Proposal for amendments to Regulation No. 79 (Steering equipment)

Proposed changes with regard to the implementation of technical specifications for Lane Departure Warning Systems (LDWS)

Note: The text reproduced below was prepared by the expert from Germany in order to introduce in Regulation No. 79 technical specifications on Lane Departure Warning Systems (LDWS). The modifications to the existing text of the Regulation are marked in ***bold and italic*** characters.

Model A

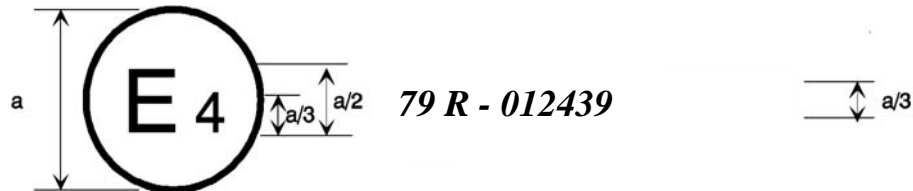
Annex 2, amend to read:

The above approval mark affixed to a vehicle shows that the vehicle type concerned has, with regard to steering equipment, been approved in the Netherlands (E4) pursuant to Regulation No. 79 under approval No. 012439. The approval number indicates that the approval was granted in accordance with the requirements of Regulation No. 79 incorporating the 01 series of amendments. ***In the case the requirement of Annex 7 are also fulfilled shall the letter “R” a number “7” in brackets following***
